ES_LPC1850/30/20/10

Errata sheet LPC1850, LPC1830, LPC1820, LPC1810

Rev. 5 — 15 July 2013

3.8 ISP.2: 'J' command in ISP mode swaps last two items

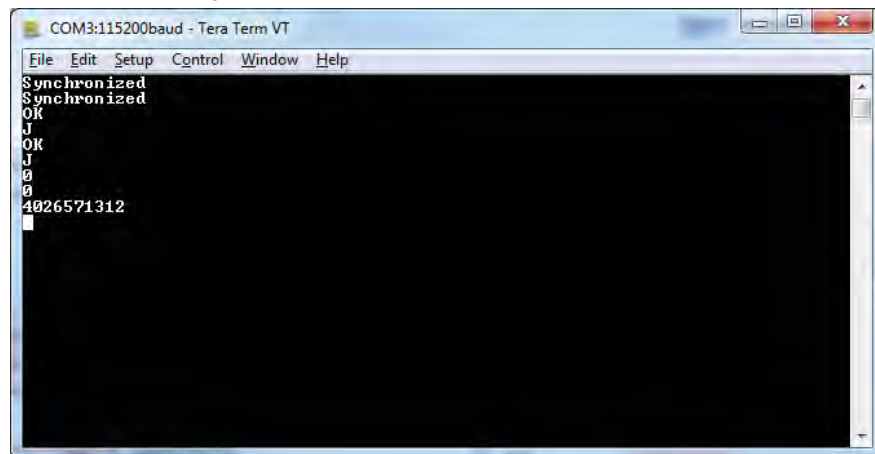
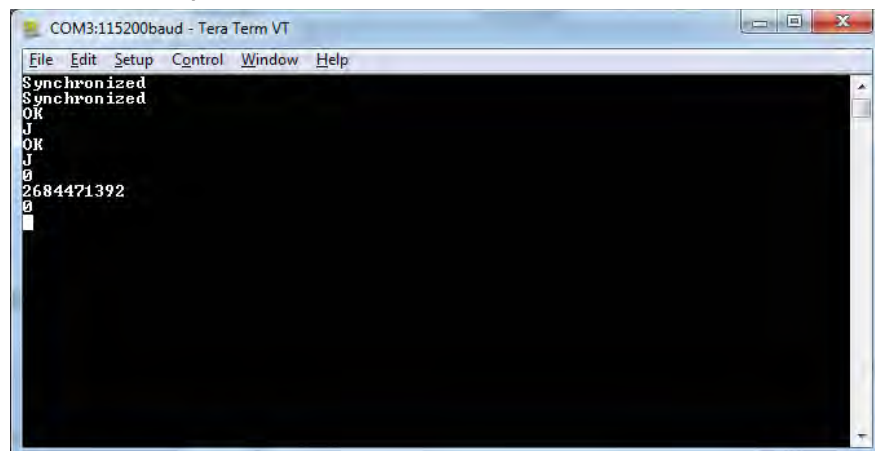
The 'J' command in ISP mode should return an error code, followed by an ASCII string representation of the part ID, followed by a 0. However what is actually returned is the error code, followed by a 0, followed by an ASCII string representation of the part ID. The problem is the last two items returned are swapped.

Incorrect example:

Correct example:

There is no work-around for this problem.

3.11 PMC.1: PMC.x power management controller fails to wake up from Deep Sleep, Power Down, or Deep Power Down

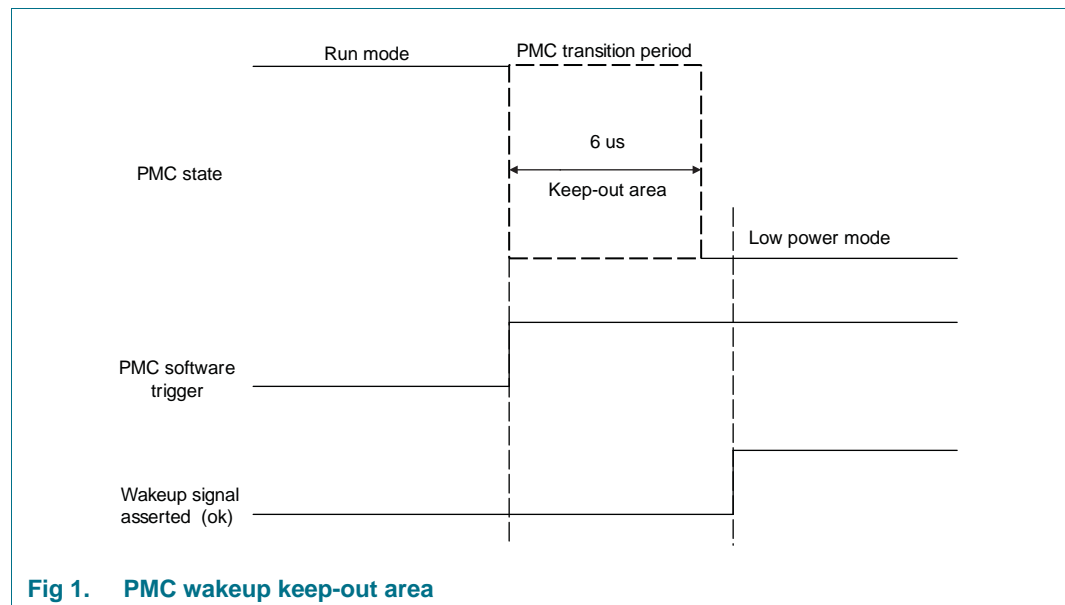
When the chip is in a transition from active to Deep Sleep, Power Down, or Deep Power Down, wakeup events are not captured and they will block further wakeup events from propagating. The time window for this transition is 6 μ S and is not affected by the chip clock speed. After a wakeup event is received during the PMC transition, the chip can only recover by using an external hardware reset or by cycling power.

Make sure that a wakeup signal is not received during the Deep Sleep, Power Down, or Deep Power Down transition period. An example circuit to work around this could include an external 6 μ S one shot which could be triggered via software using a GPIO line when entering Deep Sleep, Power Down, or Deep Power Down mode. The one-shot's output could be used to gate the wakeup signal(s) to prevent receiving a wakeup signal during the PMC transition period. Depending on the system design, it may also be needed to latch the wakeup signal(s) so that they will still be present after the one-shot's 6 μ S timeout.

3.13 USB.1: The USB controller USB0 is unable to communicate with a low-speed USB peripheral in host mode when using full-speed hub

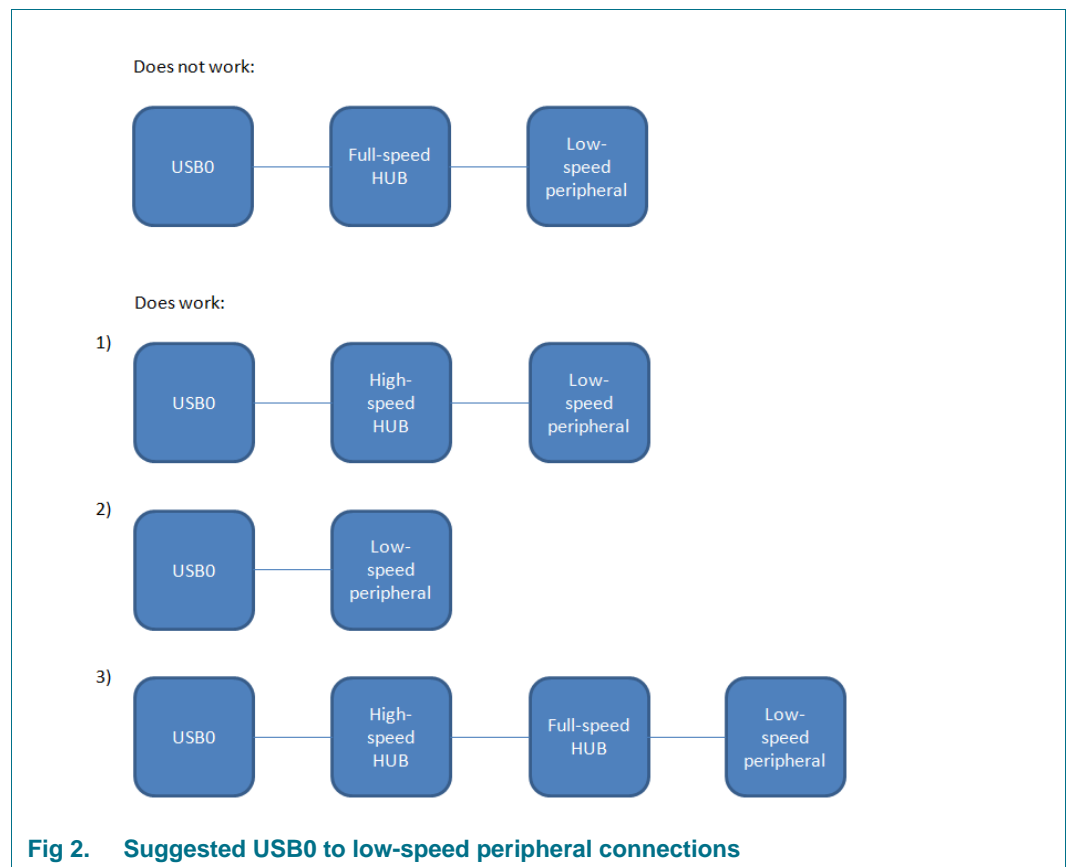
The USB controller called USB0 is unable to communicate with a low-speed USB peripheral in host mode when there is a full-speed hub directly connected to the USB0 port and a low-speed peripheral is connected in the tree somewhere below this full-speed hub. Only USB0 has this problem; the other USB controller, USB1 does not.

There is no work-around for this problem. It is suggested that the low-speed USB peripheral is either connected directly to USB0 or a high-speed hub is placed between that peripheral and USB0.
